SUBJECT: NIAGARA MOHAWK POWER CORPORATION  
DOCKET NO. 50-220

CO REPORT NO. 220/65-2

Title: NIAGARA MOHAWK POWER CORPORATION  
LICENSE NO. CPPR-16

Figure 2

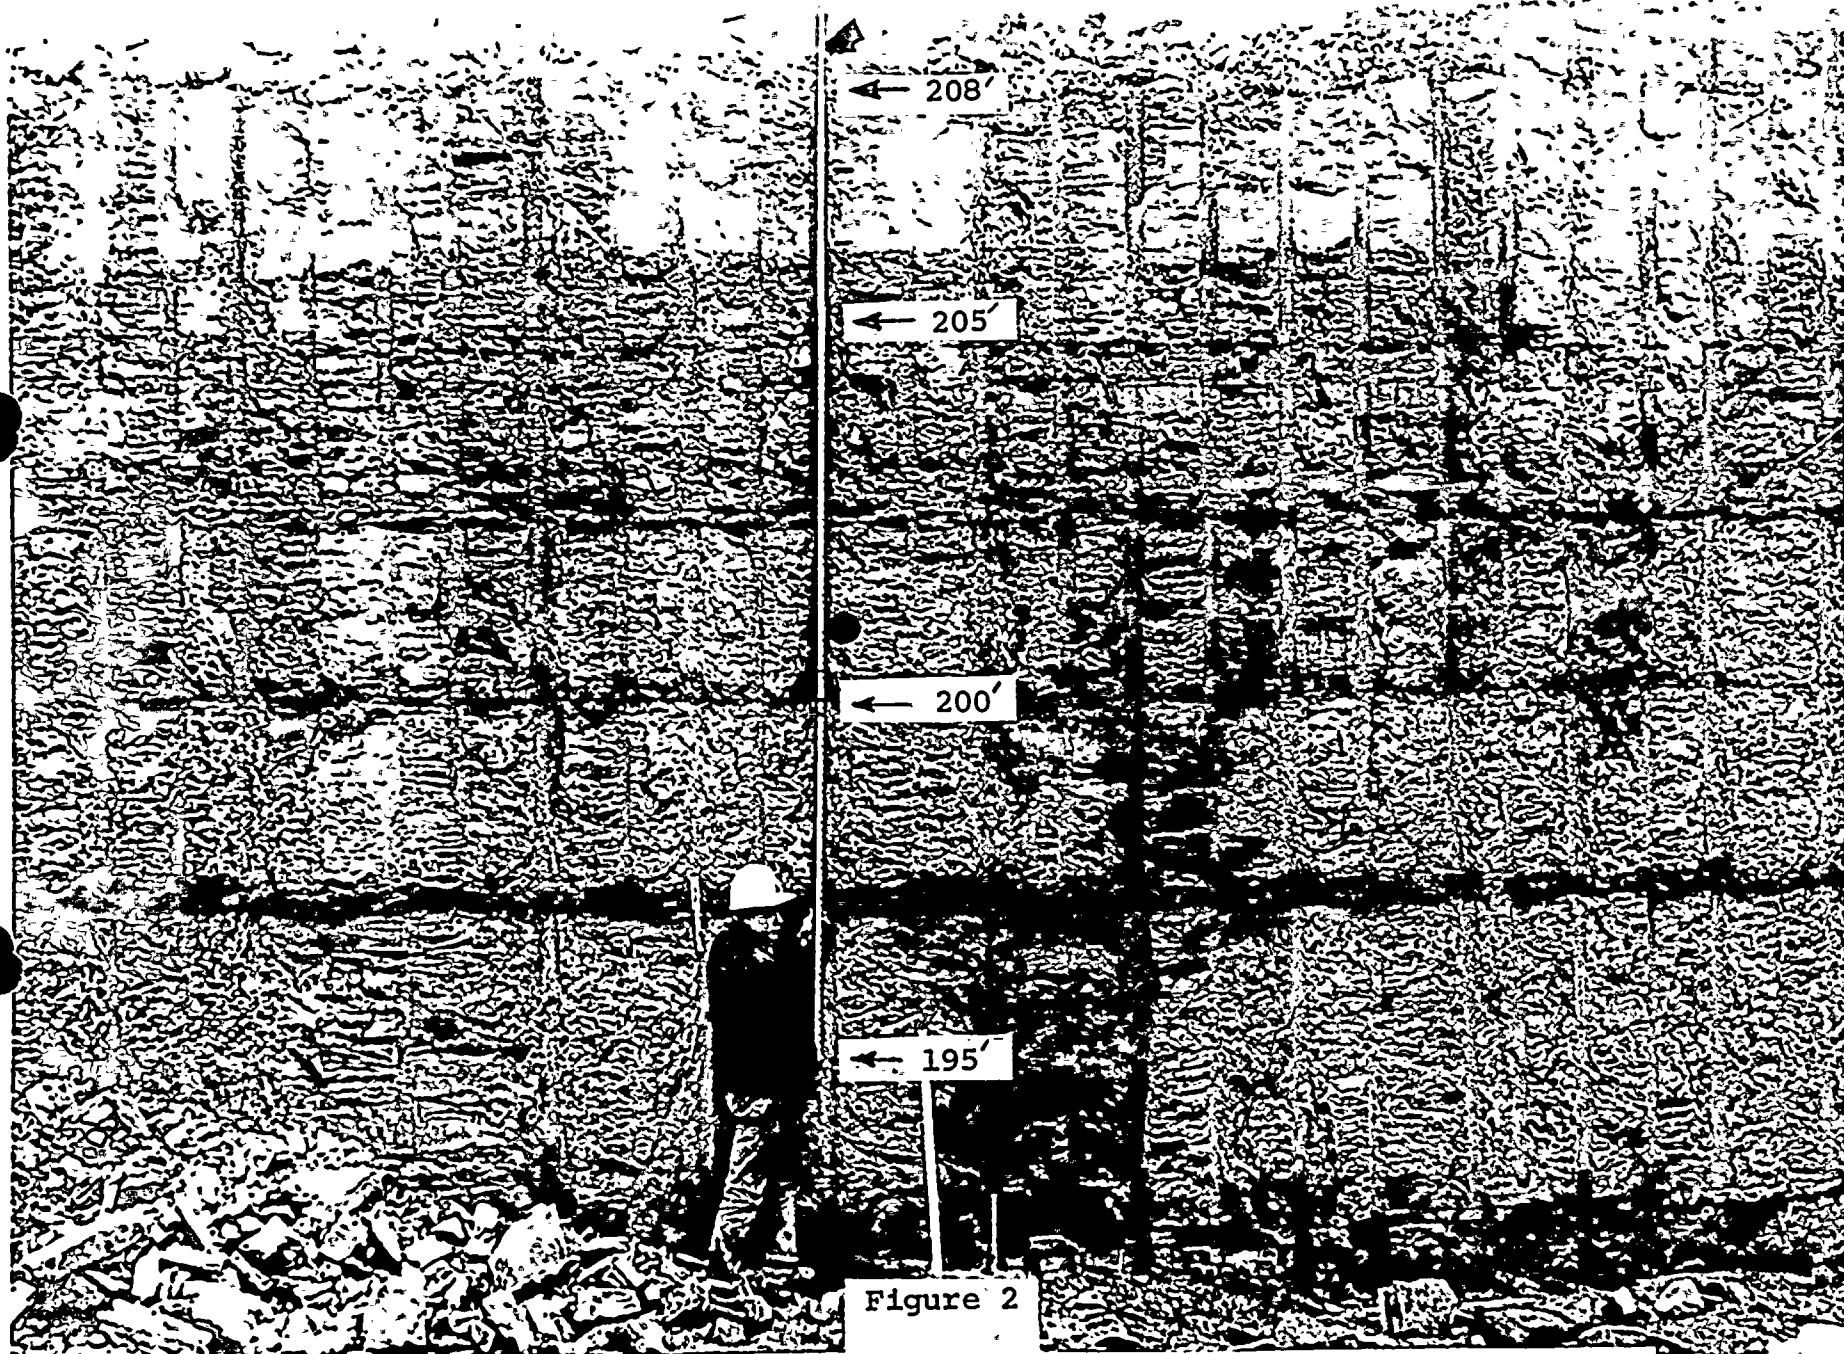
- a. The pedestal is approximately 100' in diameter and 15' high. The damage amounted to a movement of the rock mass of the pedestal along three shaly, horizontal, strata. The displacement totaled 8", mostly at an elevation of 197'. A slight rotational movement was also experienced. The horizontal and rotational displacements of the pedestal are shown in Figures 1 and 2.
- b. The movement is attributed to a combination of: horizontal and vertical rebounding following removal of overburden and rock around the pedestal; and blasting operations, some shots of which exceeded the maximum charge recommended by D&M.

Figure 3

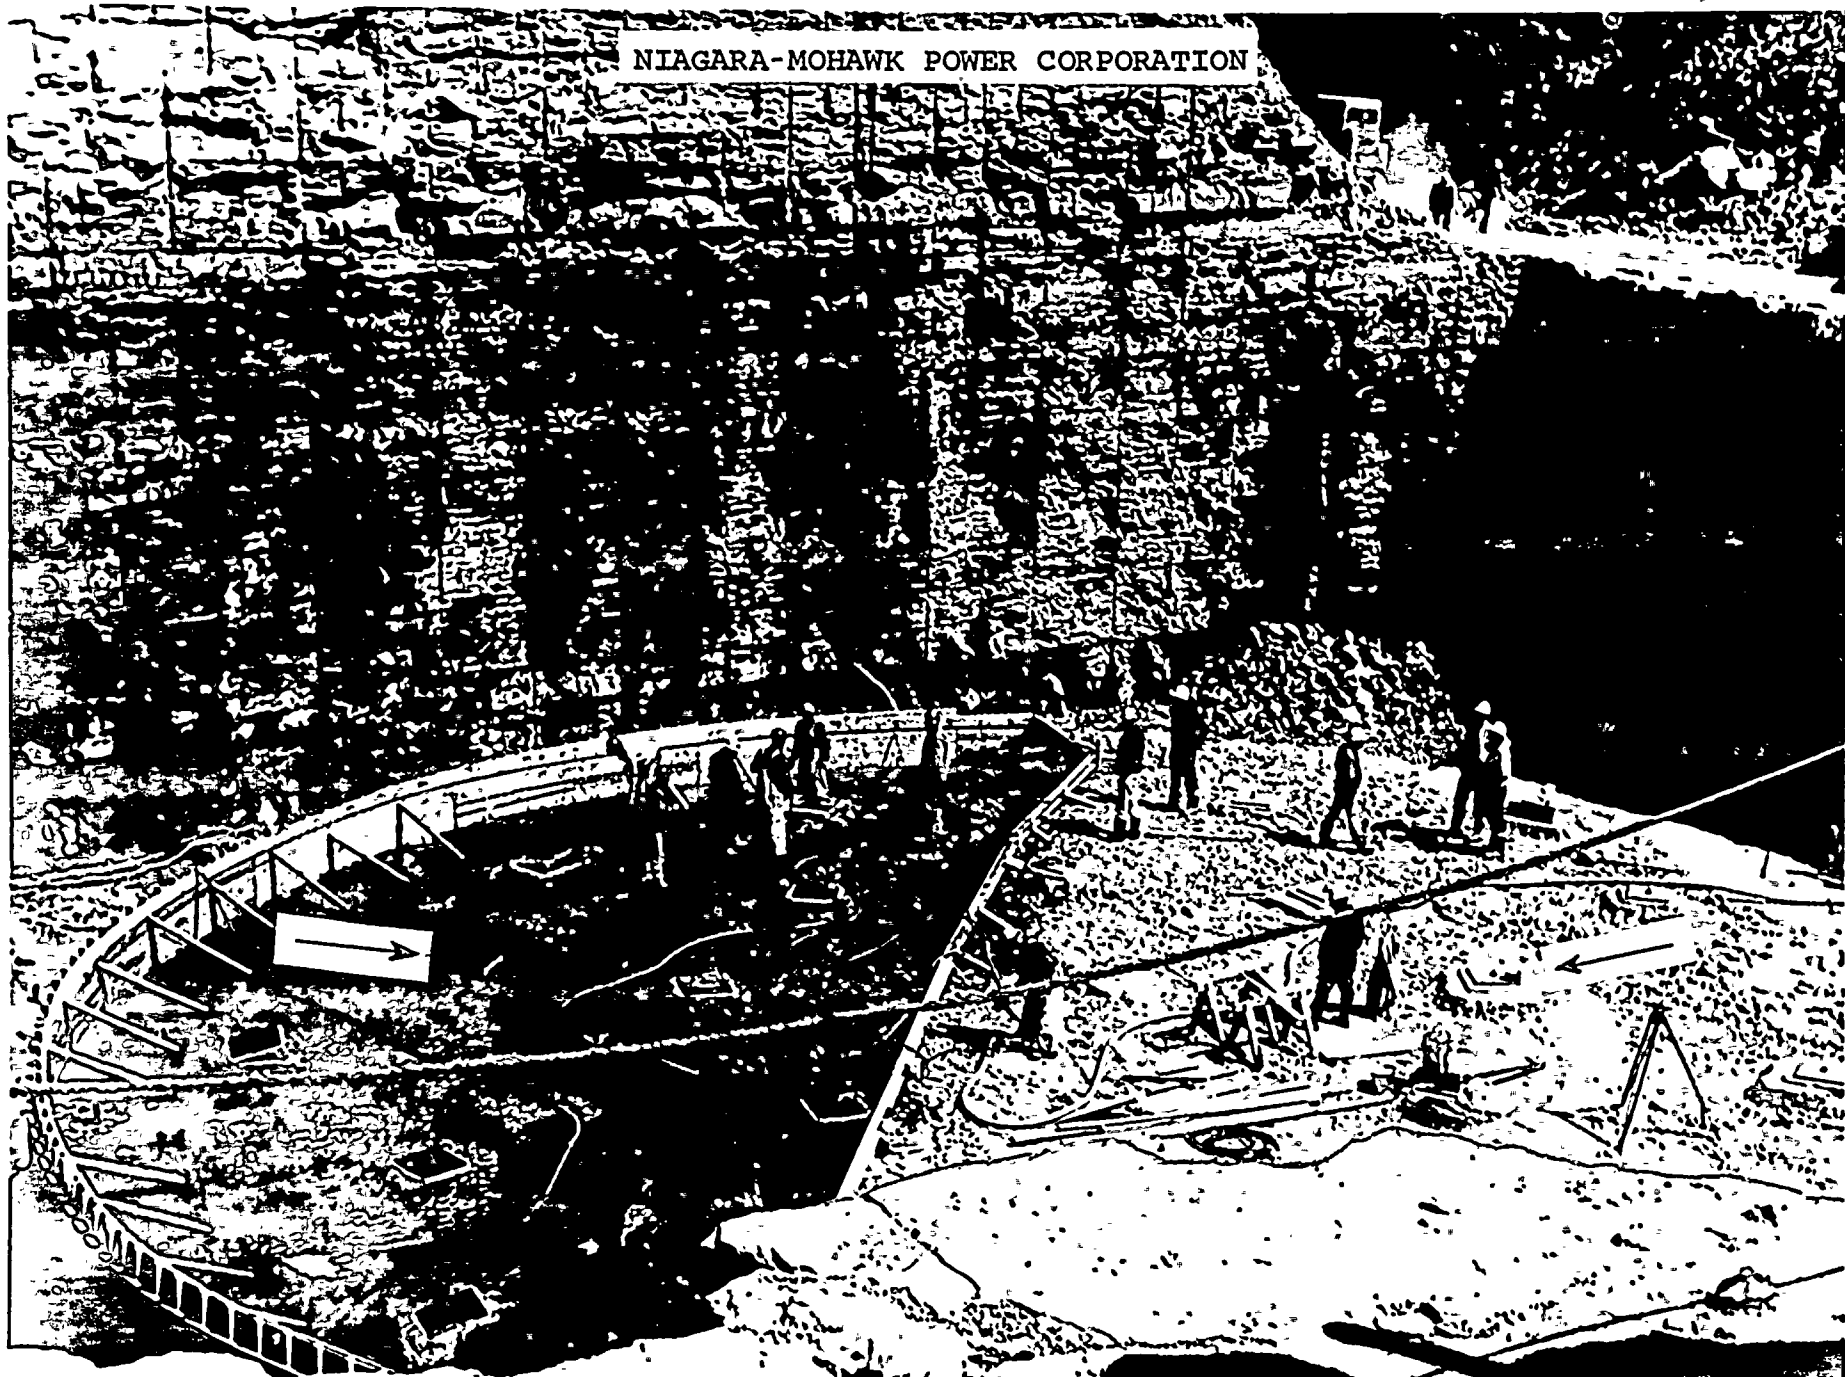
- e. Restoration of the pedestal included the following:
  - (1) The installation of a total of 24 rock bolt anchors, in three concentric circles, to a depth of approximately 5' below the torus excavation.

- (2) The placing of the bolts in post-tension to restore the effective weight of the overburden removed.
- (3) The grouting of the bolts.
- (3) The pressure grouting of the pedestal, in general, via holes drilled for this purpose.

Figure 3 is a view of the top of the pedestal showing anchor locations. Also shown is the form used for a concrete pour made to replace rock removed in excess of that originally intended.
